MEMORANDUM

Computer • DIVISION OF BENDIX AVIATION CORPORATION

SUBJECT: Changes to the G-15 -- Effective
Serial #~~309~~
311

DATE: April 12, 1960

-45A-

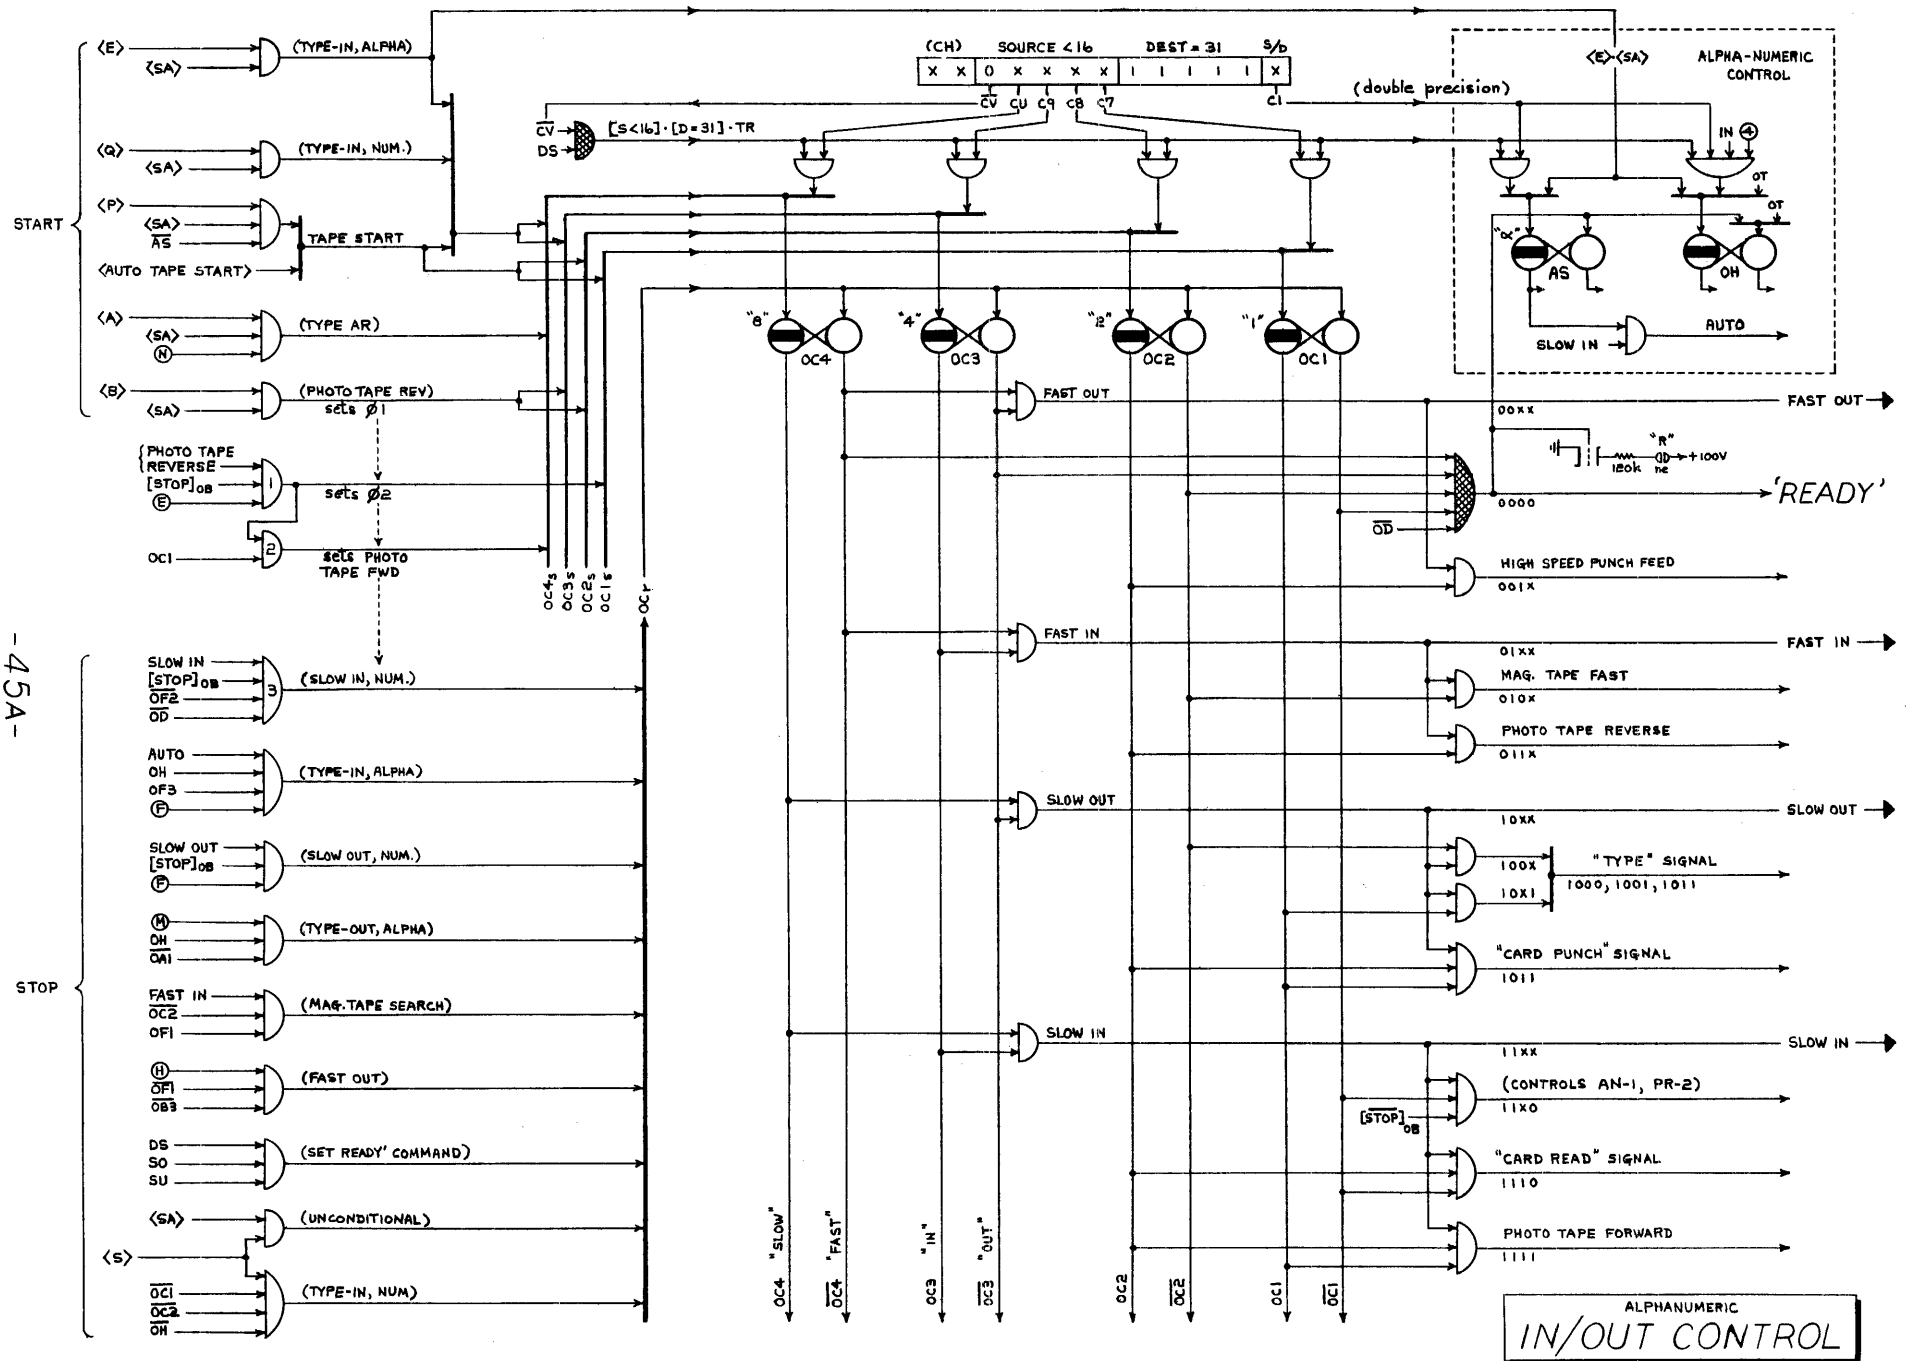
Attached you will find three revised TRAINING PRINTS as follows:

45A	ALPHANUMERIC	IN/OUT	CONTROL
48A	ALPHANUMERIC	INPUT	
52A	ALPHANUMERIC	SLOW OUT

These are supplements to your present drawings #'s 45, 48, and 52. The new prints show the hardware to be found in machines affected by ECO 1096 (presumably starting with machine #309). The three drawings exhibit the hardware forming all of the new IN/OUT equations except 9c, 24, 25.

PR-2 CONTROL CIRCUIT

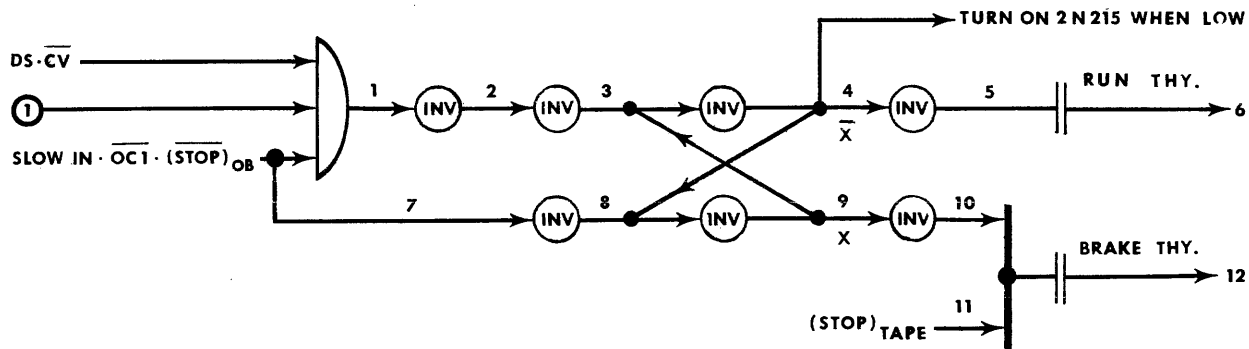
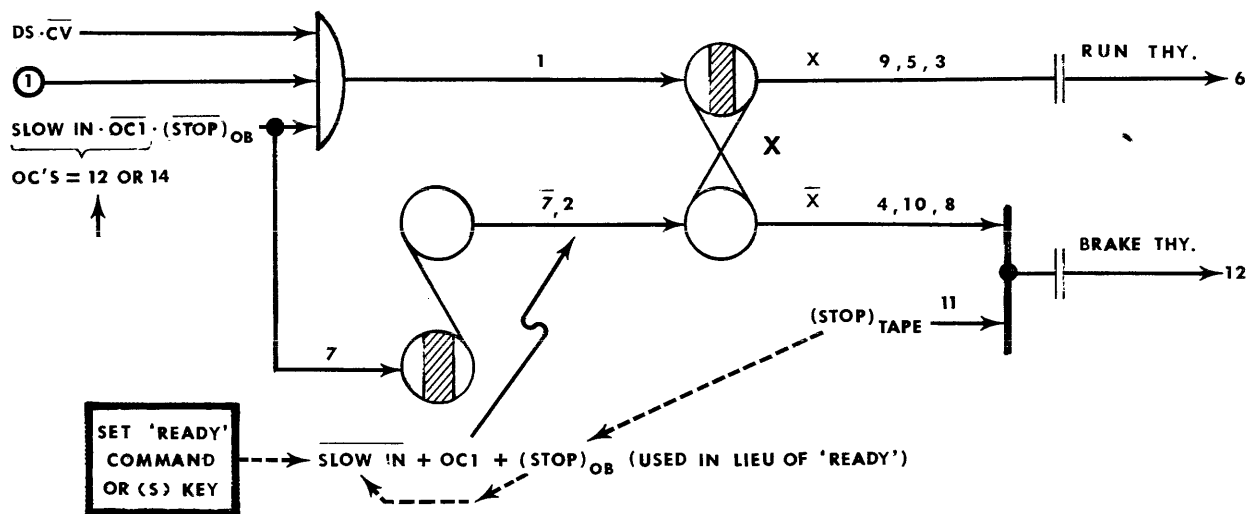
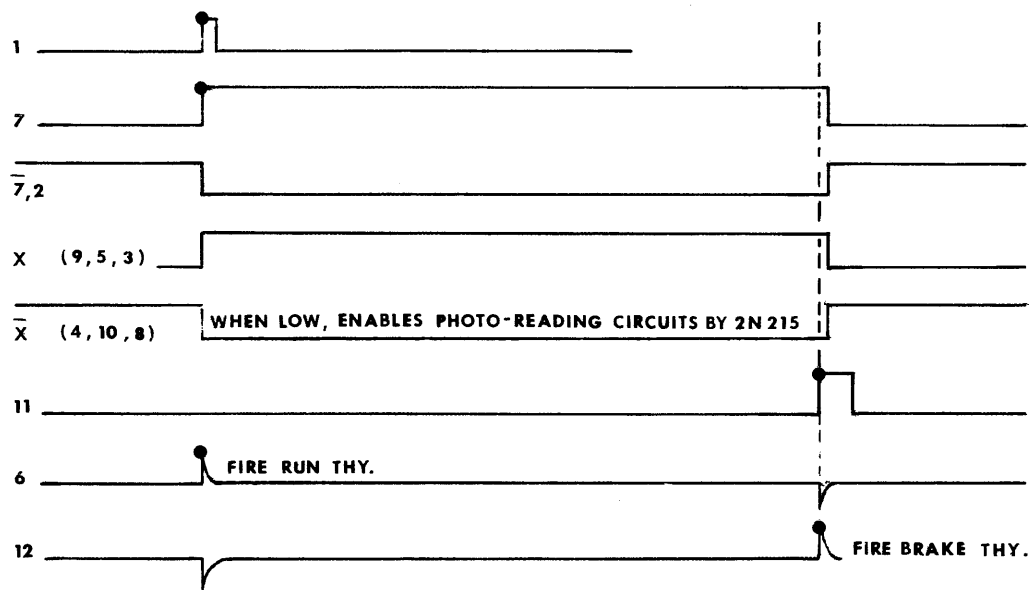
- 23 Is now $\langle \text{E} \rangle \cdot \langle \text{SA} \rangle$ -- improves reliability.
- 24,25 These equations have not been changed, but do warrant further explanation. They are "effective" equations which means that terms which logically "drop out" are not shown. The attached drawing of "PR-2 CONTROL" should clarify this.

Your copy of drawing #60 should be marked-up to indicate that $\overline{\text{AS}}$ has been added to the $\text{FAST OUT} \cdot \text{OD} \cdot \text{G}$ gate which sets OE -- this will take care of eq. 9c. Eqs. 24 and 25 are handled on the "PR-2 CONTROL" drawing mentioned above.
